HISTORIC AND DESIGN REVIEW COMMISSION

HDRC CASE NO: 2023-173
ADDRESS: 300 ALAMO PLAZA
LEGAL DESCRIPTION: NCB 115 BLK LOT ALL OF BLK & P-100(.209AC)
ZONING: D, H, RIO-3, Public Property
CITY COUNCIL DIST.: 1
DISTRICT: Alamo Plaza Historic District
APPLICANT: Kate Rogers, Alamo Trust, Inc.
OWNER: City of San Antonio
TYPE OF WORK: Site work, Construction of Plaza de Valero
APPLICATION RECEIVED: April 28, 2023
60-DAY REVIEW: Not applicable due to City Council Emergency Orders
CASE MANAGER: Edward Hall

The applicant, Alamo Trust, Inc., is requesting a Certificate of Appropriateness for approval to construct Plaza de Valero within the Alamo Plaza Historic District. The proposed scope of work includes the installation of new paving, the relocation of existing trees, the installation of planting beds, landscaping element and trees, the construction of a pavilion, and the site utility work.

HARDSCAPE | PHASE 2A/2B

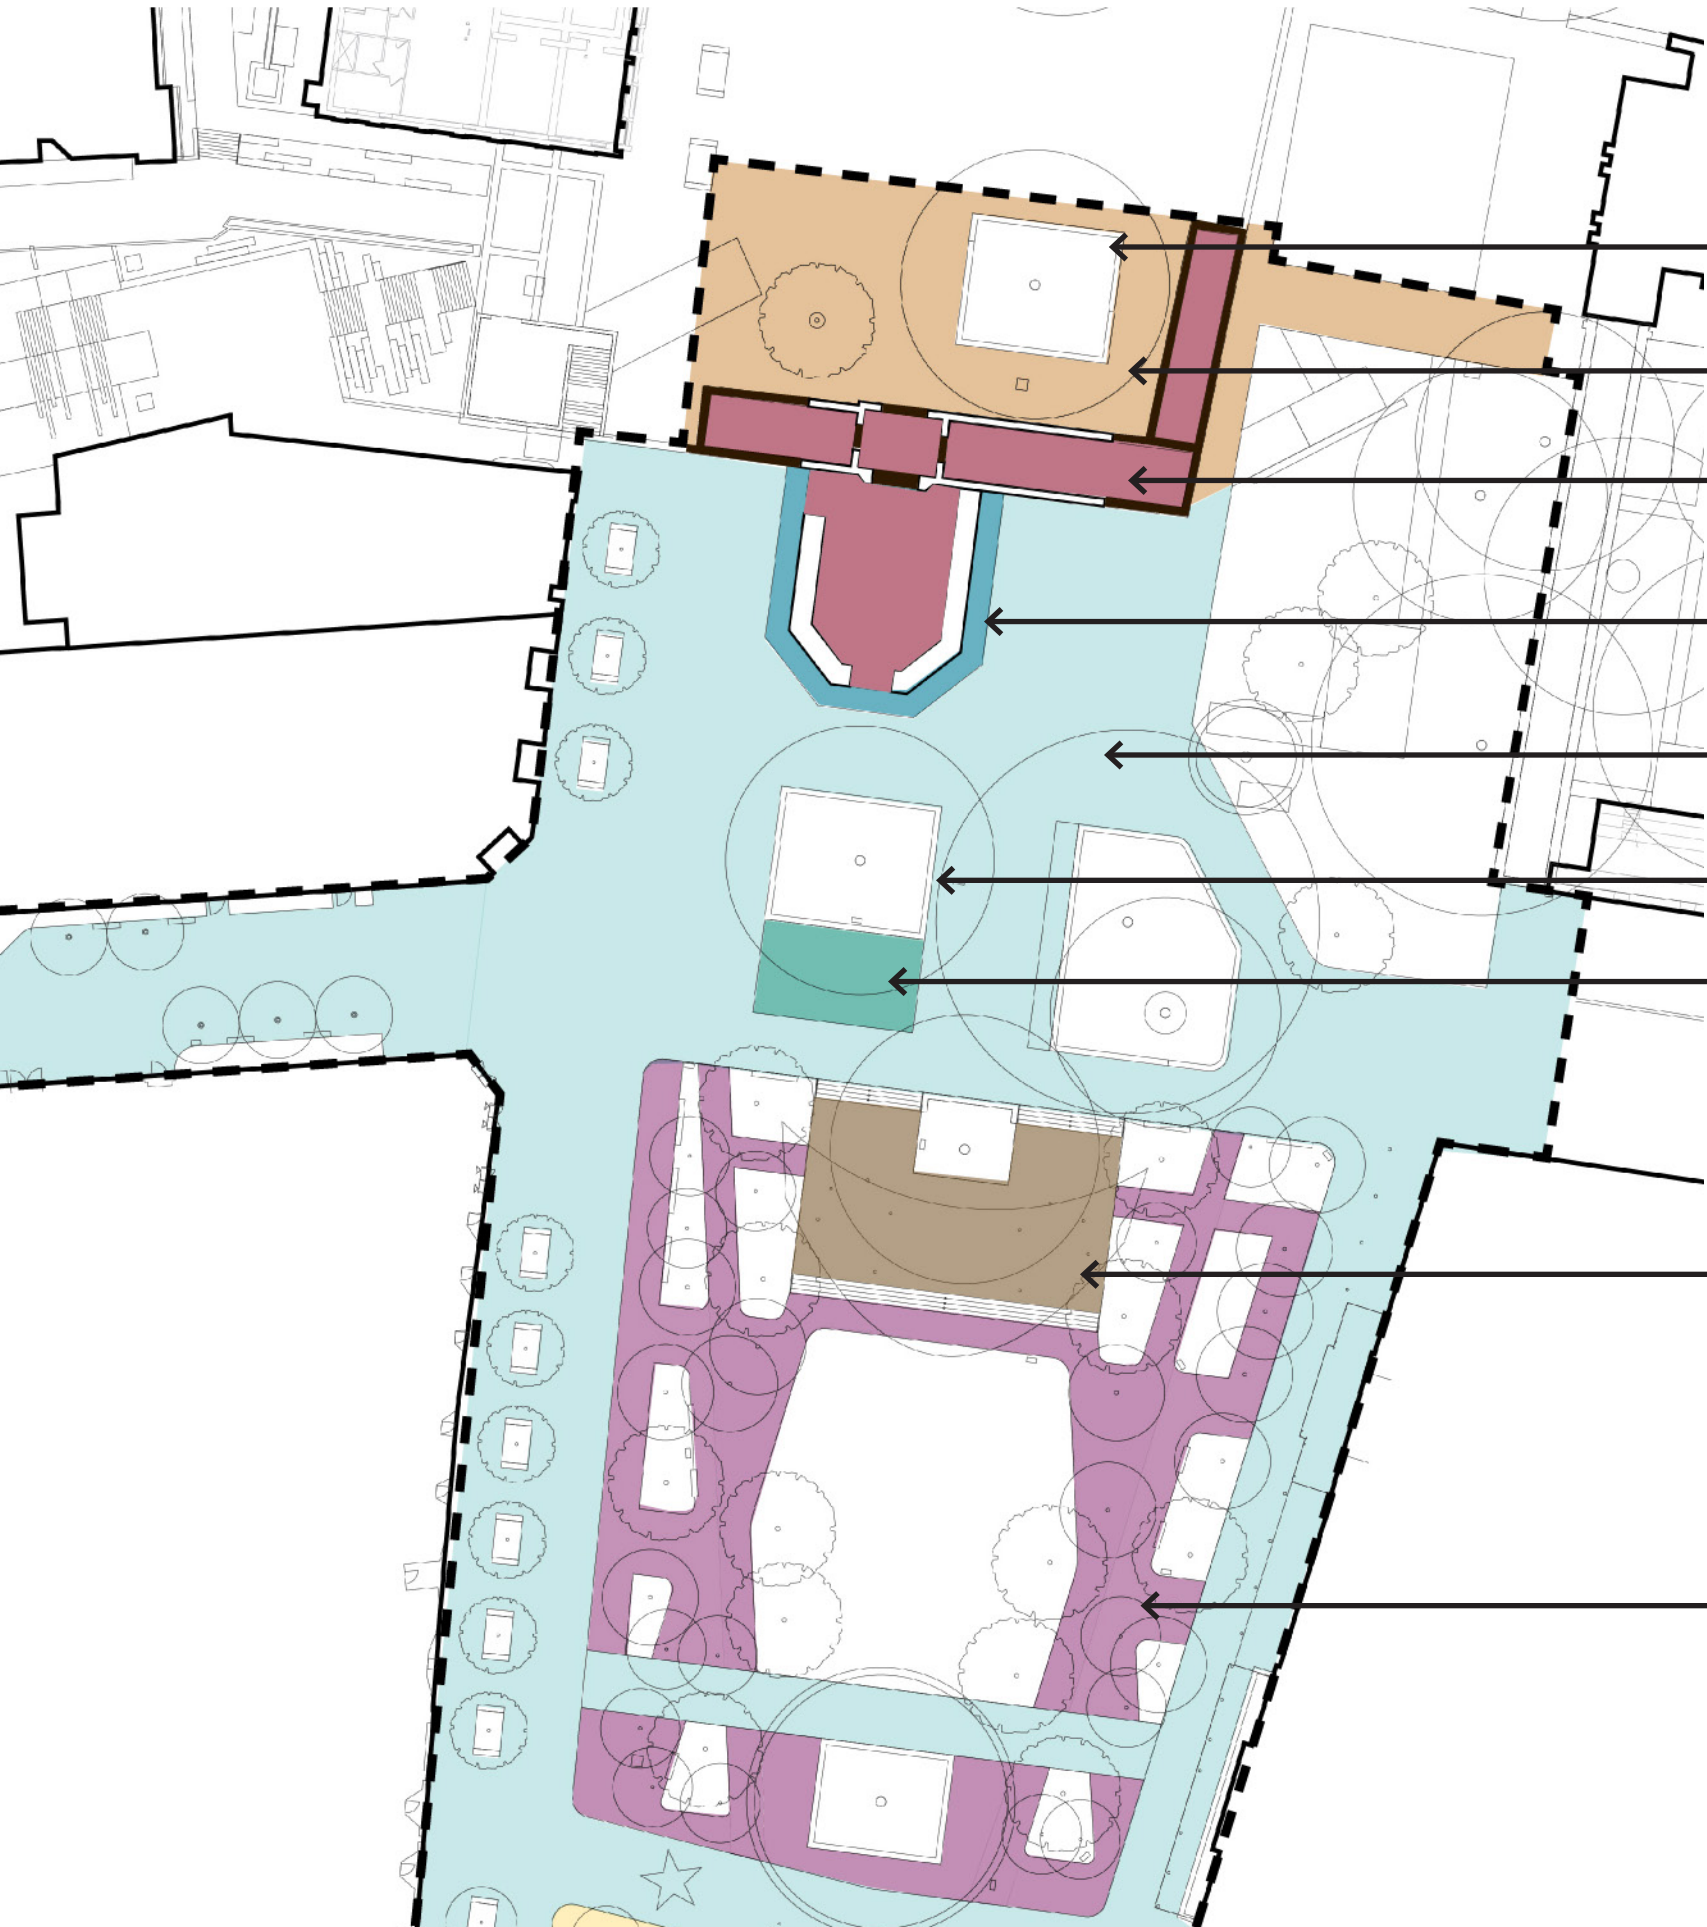
- d. SITE PAVING – The applicant has proposed site paving materials that include granite pavers and vehicular limestone pavers. The proposed site paving has been proposed in

- e. PAVILION (Primary Materials) – The applicant has proposed to construct an open-air pavilion to be located between the previously approved Mission Gate & Lunette. The pavilion will feature a raised deck to protect the root zones of existing trees. The proposed pavilion will feature primary materials that feature steel columns, wood soffits and aluminum roofing and fascias. The proposed steel and aluminum elements will feature an architectural finish. Generally, staff finds these materials to be appropriate; however, the design team is responsible for submitting final materials and finish specifications to OHP staff for review and approval.

- f. PAVILION (Paving and Secondary Materials) – The applicant has proposed for the pavilion to feature a raised, wood platform deck and stone steps. Staff finds these materials to be appropriate. Stone steps should be complementary of stone found historically within the district.

- i. That the design team submit final materials and finish specifications for the proposed pavilion to OHP staff for review and approval, as noted in finding e.

- ii. That the design team submit final materials and specifications for the proposed pavilion steps to OHP staff for review and approval, as noted in finding f.
